Re: Niagara Mohawk Power Corporation
Nine Mile Point Unit 1
AEC Docket No. 50-220

AMENDMENT NO. 2 TO APPLICATION TO
CONVERT PROVISIONAL OPERATING LICENSE
TO FULL-TERM OPERATING LICENSE

The following are responses to AEC questions transmitted to Niagara Mohawk Power Corporation on February 7, 1974.

Figure 3.2.2.a

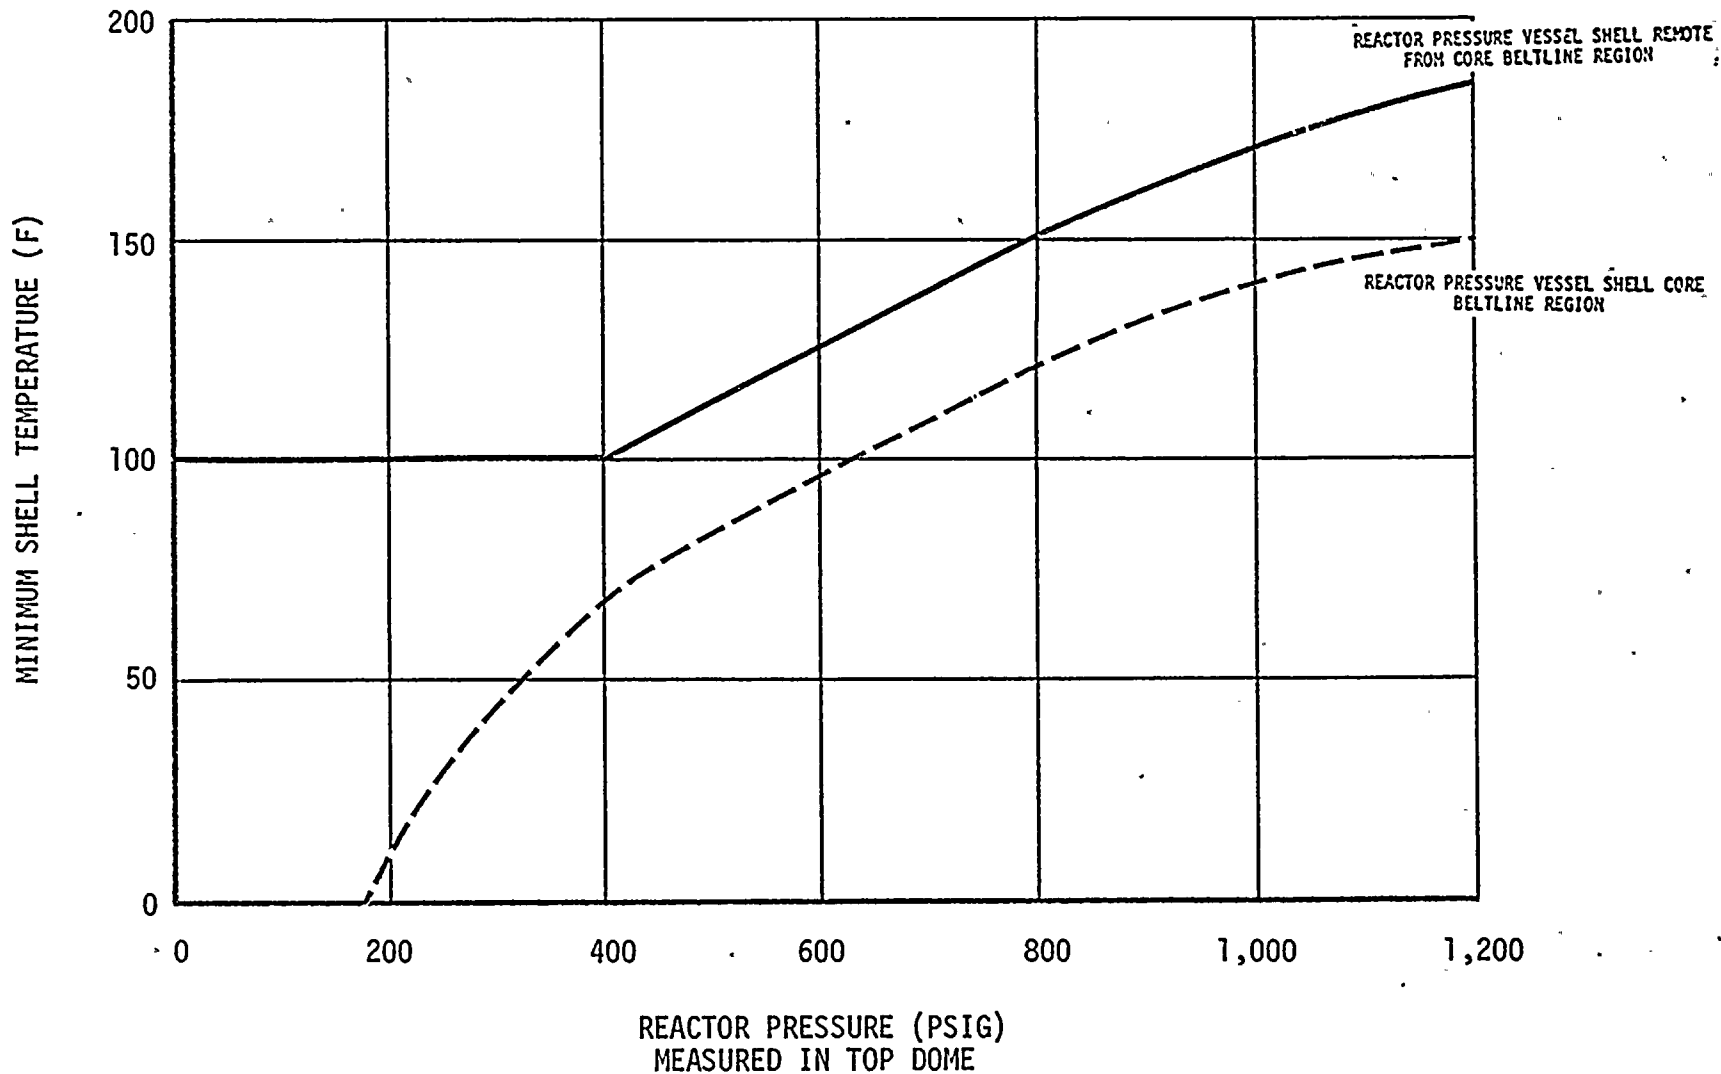
The proposed technical specification regarding fracture toughness of the primary coolant system materials is unacceptable and should be rewritten incorporating the provisions of Appendix G, 10CFR Part 50 as far as practical. Provide curves of the limitations on heatup and cooldown rate and the limits for core operation in accordance with Section IV A 2 C. (sic) of Appendix G, 10CFR Part 50.

The proposed revision to the technical specification is attached and noted by marginal markings. It should be noted that the specification is in accordance with Section IV A 2 C of Appendix G, 10CFR Part 50.

CONTAINMENT ATMOSPHERE DILUTION SYSTEM WITH BACK-UP VENTING

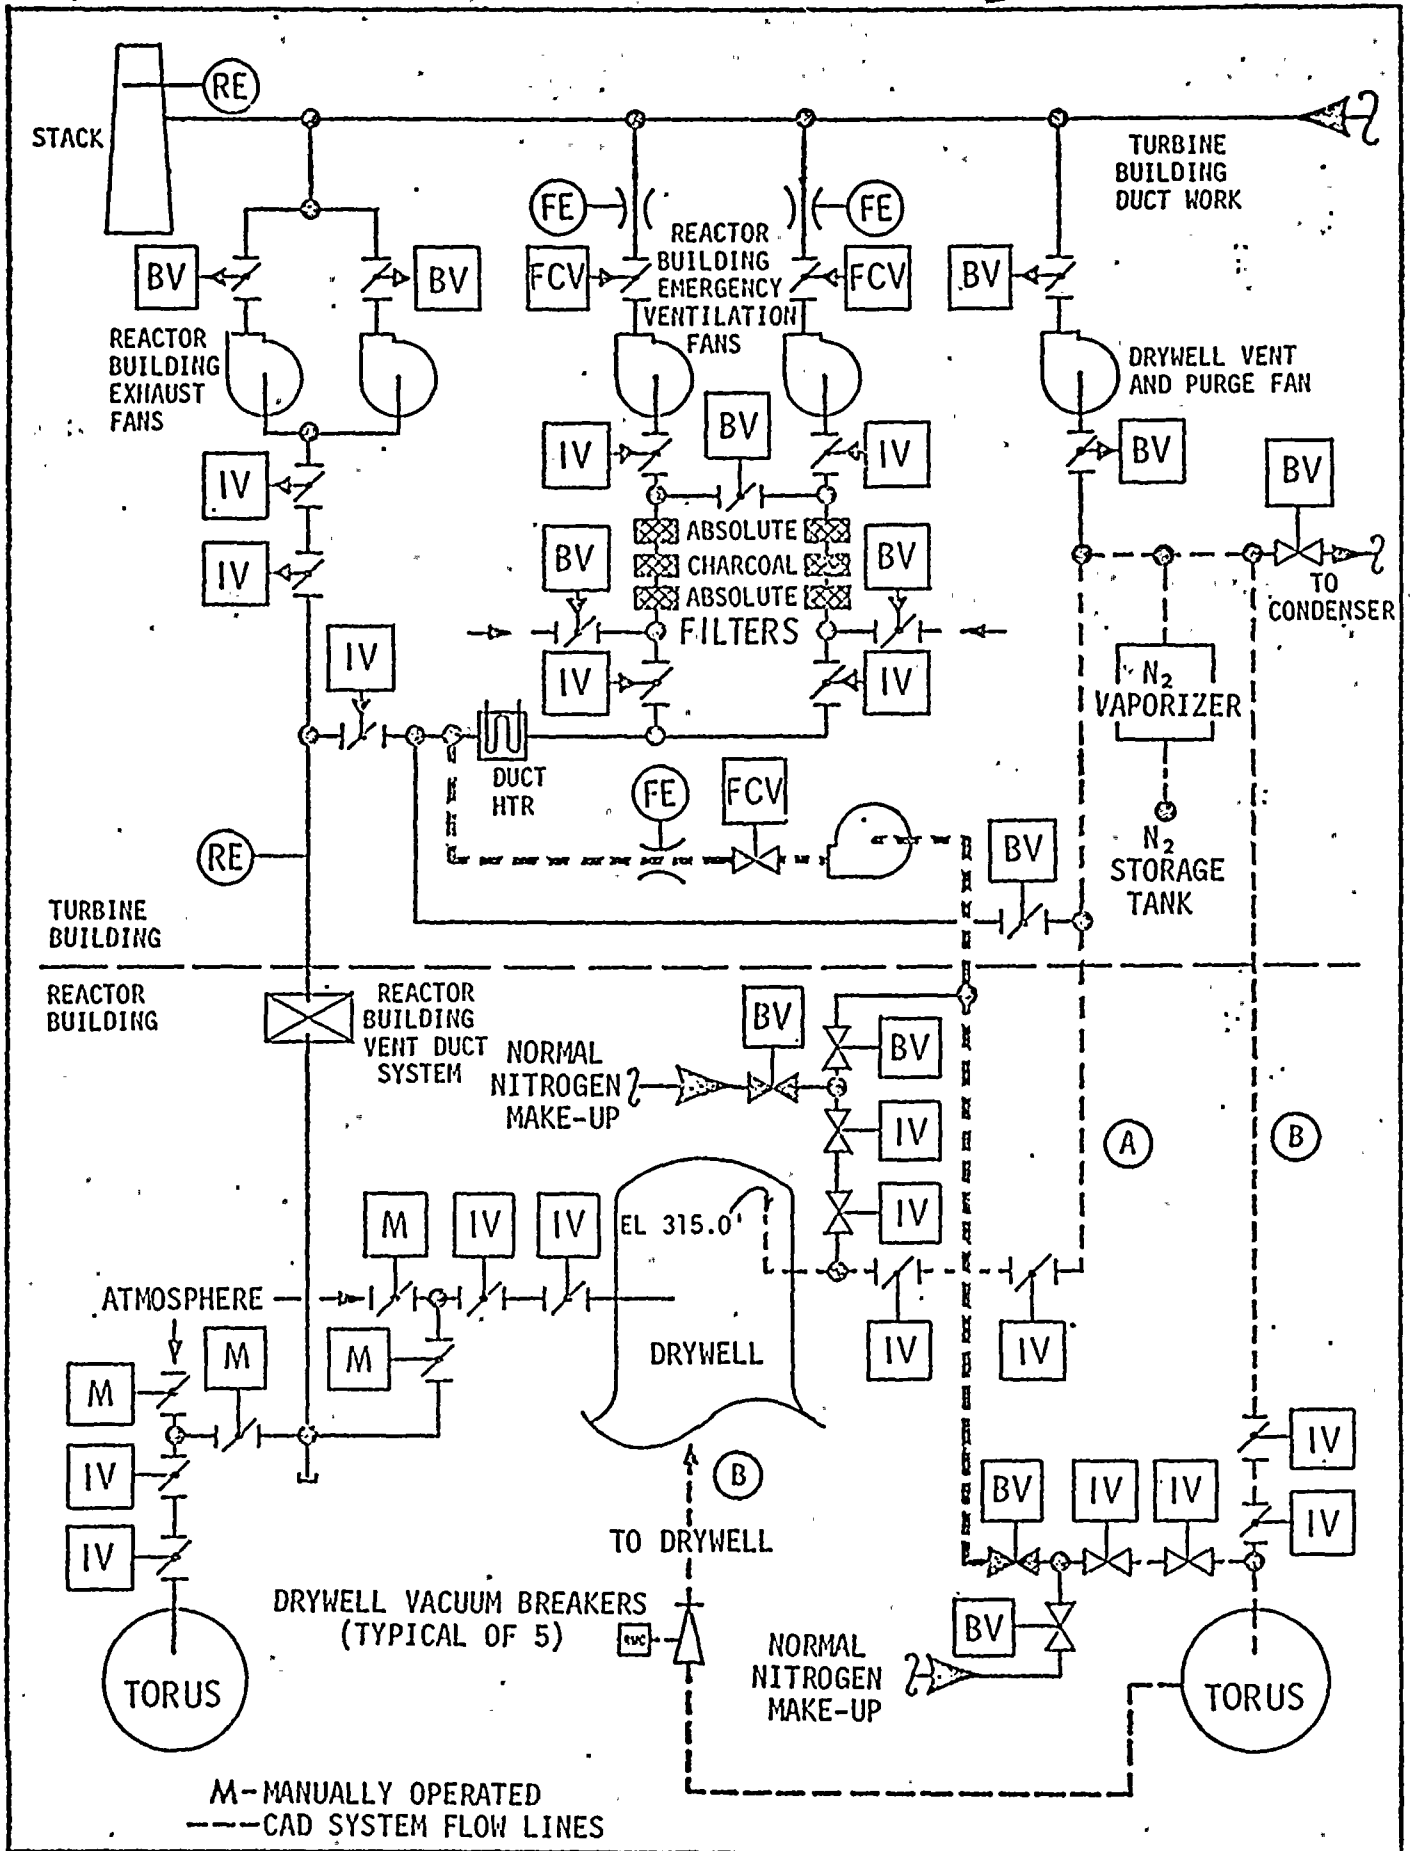
- d. The design of the CAD system should be modified to provide active redundancy in the valve arrangements.
- e. The oxygen sampling system should be designed to engineered safety feature standards, including redundant oxygen analyzers each being capable of sampling several locations within the drywell and torus.

- d. Figure 1-1 is a flow diagram of the CAD system, showing the nitrogen make-up paths and the vent path to the reactor building emergency ventilation system. Two redundant paths A and B for nitrogen addition exist. Path A supplies nitrogen to the drywell with subsequent flow to the suppression chamber. Path B supplies nitrogen to the torus and then with subsequent actuation of the drywell vacuum breakers to the drywell. Venting of containment atmosphere can be from either the drywell or the torus.
